Name Of Dam: WHEATLANDS
Location: FREDERICK COUNTY, VIRGINIA
Inventory Number: VA 06913

PHASE I INSPECTION REPORT NATIONAL DAM SAFETY PROGRAM.

Wheatlands Dam. (Inventory Number VA-06913),
Potomac River Basin. Frederick County,
Virginia. Phase I Inspection Report.

FIELD SKETCH
WHEATLANDS DAM
 FREDRICK, CO. VA.
 29 OCTOBER 80
 N.T.S.
PLATE I
APPENDIX III

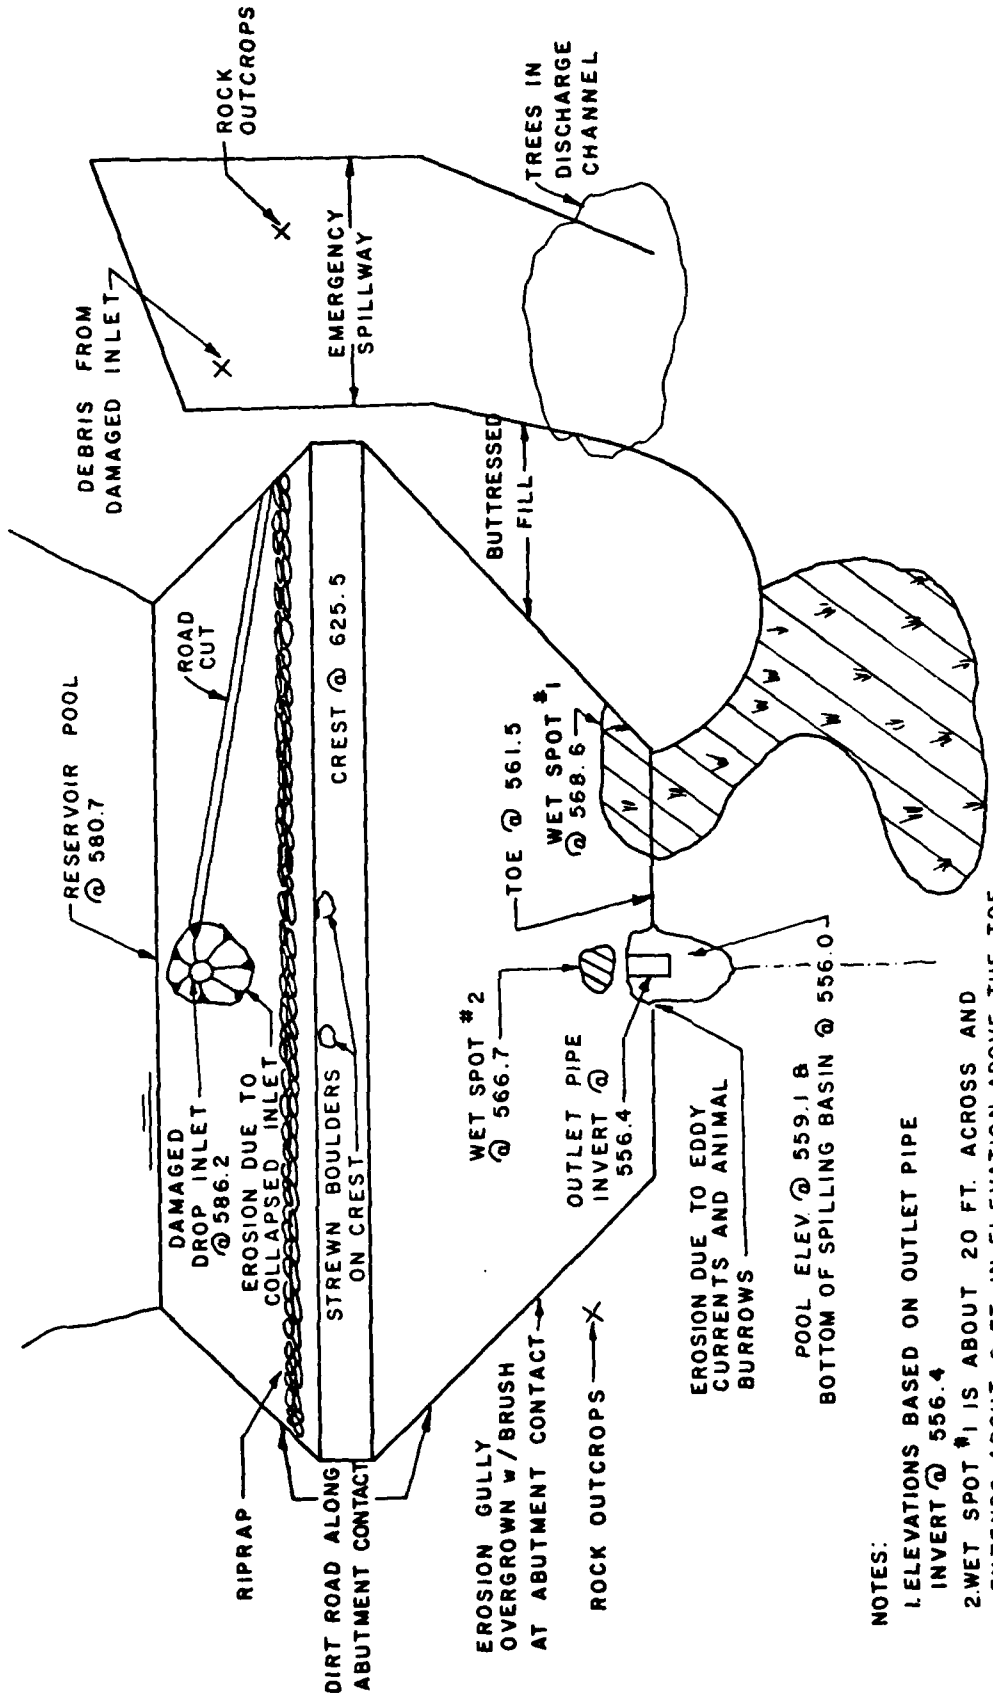
- NOTES:
1. ELEVATIONS BASED ON OUTLET PIPE INVERT @ 556.4
 2. WET SPOT #1 IS ABOUT 20 FT. ACROSS AND EXTENDS ABOUT 6 FT. IN ELEVATION ABOVE THE TOE. THE SPOT SUPPORTS SWAMP LIKE VEGETATION. THE WET SPOT EXTENDS ABOUT 100 FT. DOWNSTREAM, HARBORS SWAMP LIFE GROWTH AND HAS STANDING WATER.
 3. A SECOND WET SPOT IS LOCATED ABOUT 10 FT. UP FROM THE DISCHARGE PIPE. THE SPOT IS ABOUT 7' ROUND.

SHEET 3 of 9

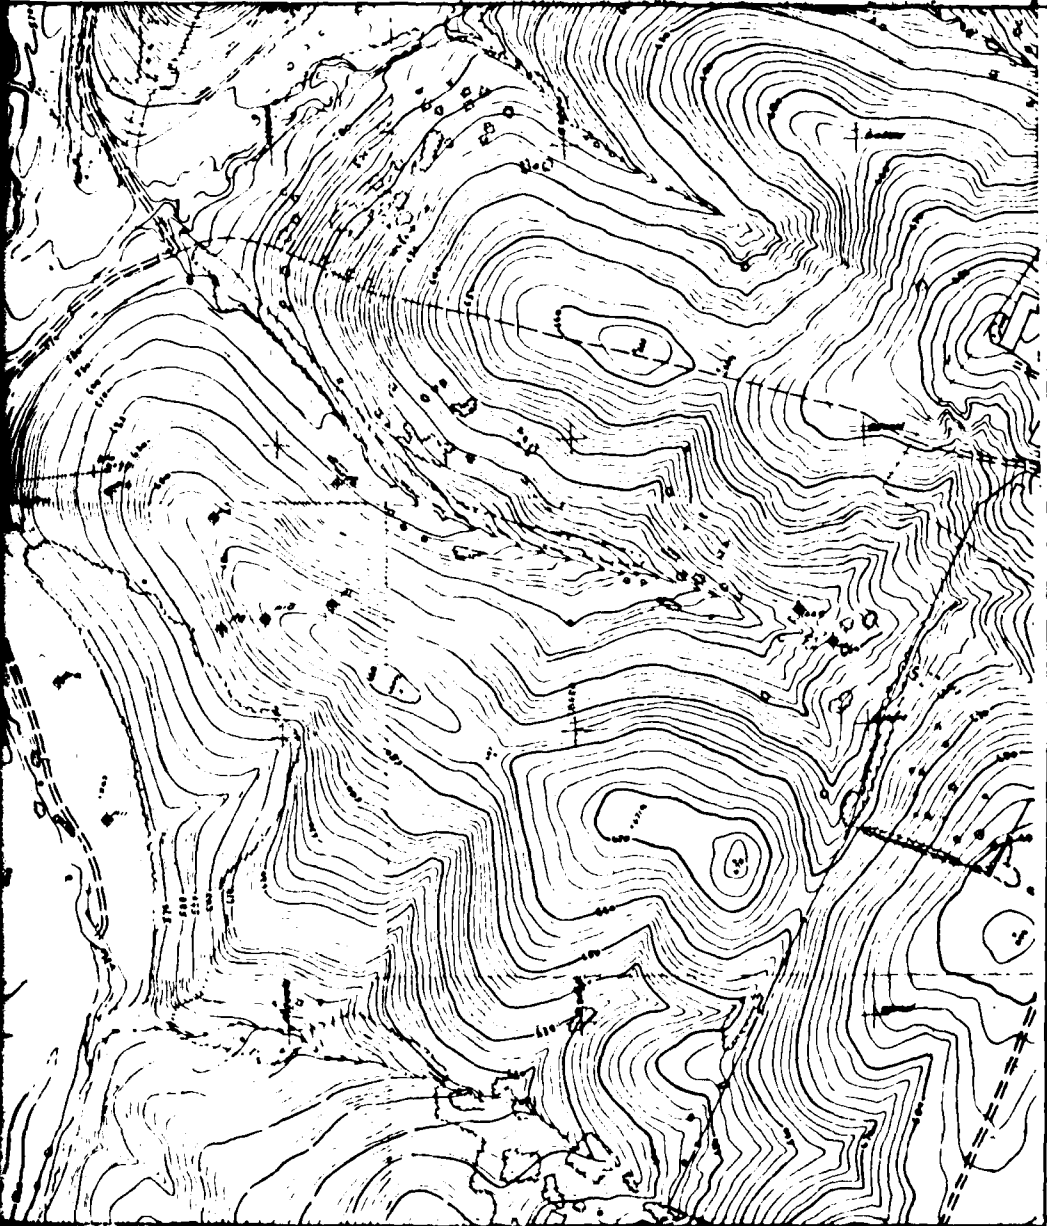
- 1) A rock toe drain could be and should be installed.
- 2) Back of dam should be seeded promptly.
- 3) Trash rack was not installed in front of 24" comp. Needs to be.
- 4) Trash rack on Riser was not correct - needs to be redone.
- 5) Out flow channel should have rock or small rip-rap along sides to maintain channel from silta-tion. Also-channel needs to be dredged out after recent rains.

SHEET 4 of 9

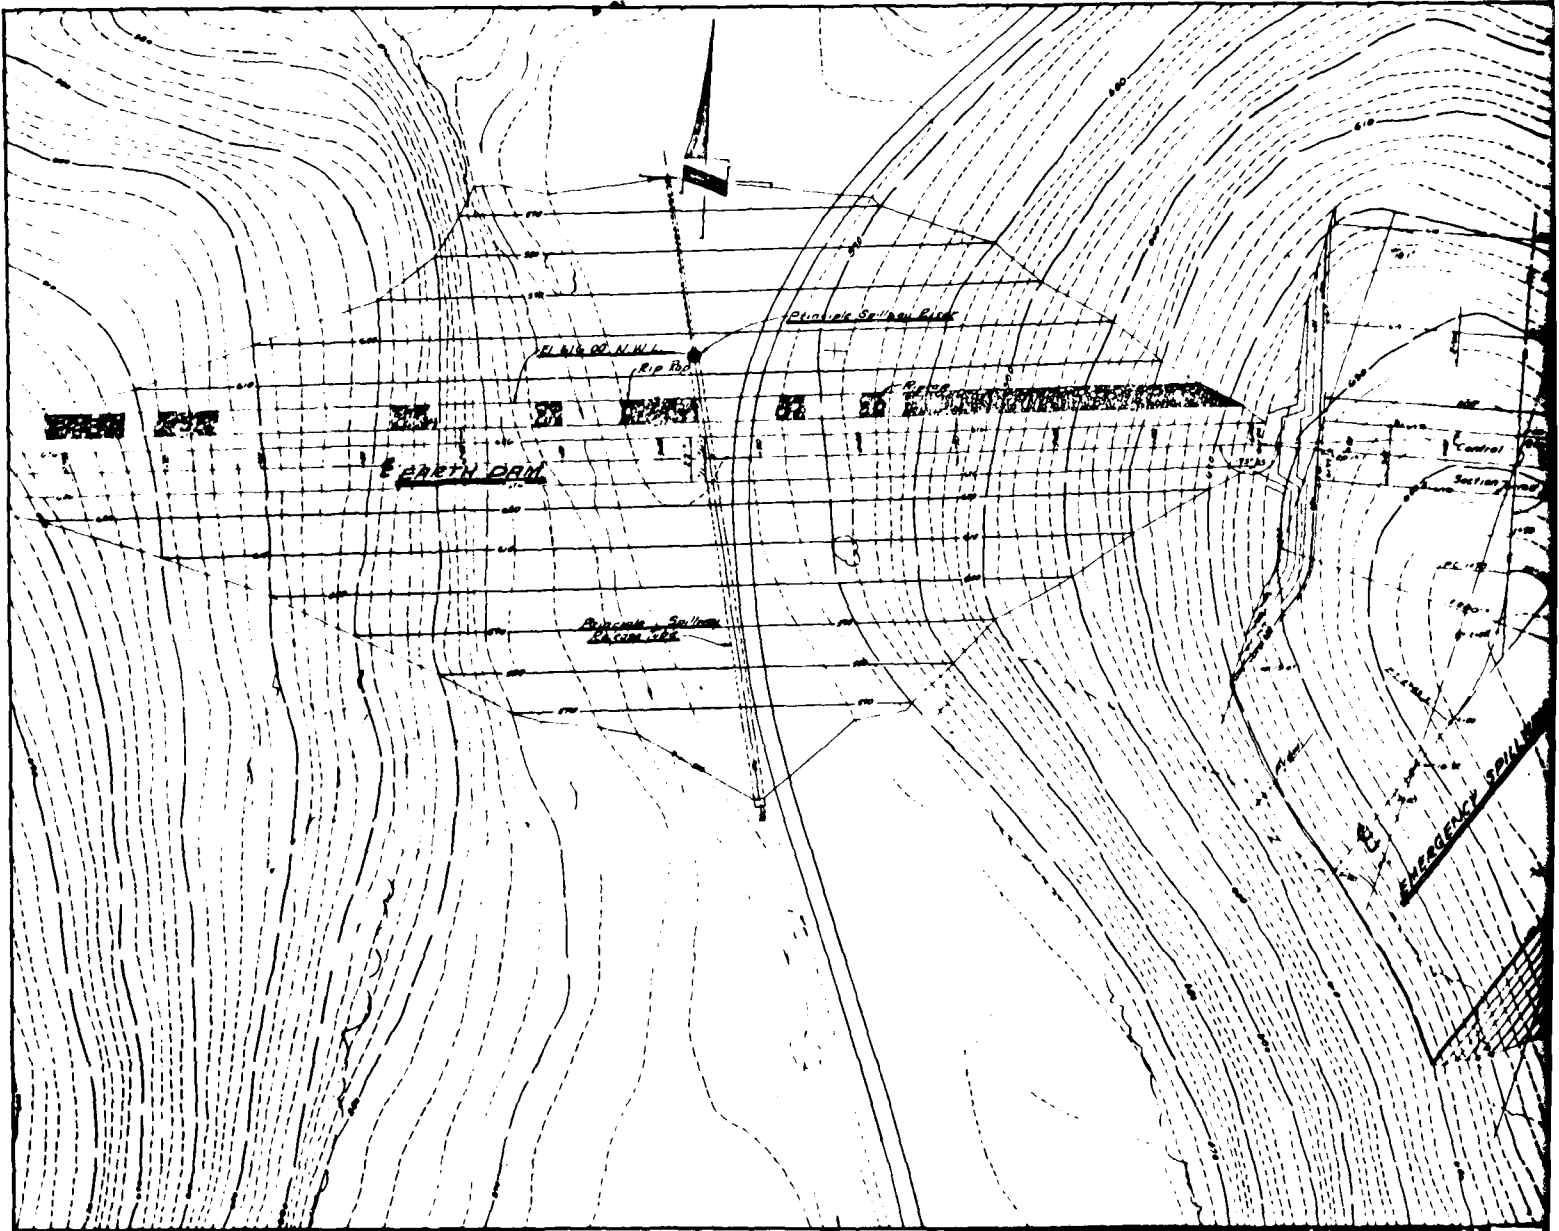
Bern built of spillway soil and rock - if you want to show.

This was not inspected so would have to be located if desired to be placed on final drawing.

Road entrance from east-across spillway and across dam top not shown. Perhaps not wanted on this drawing.

Otherwise - Sheet 4 seems O.K.
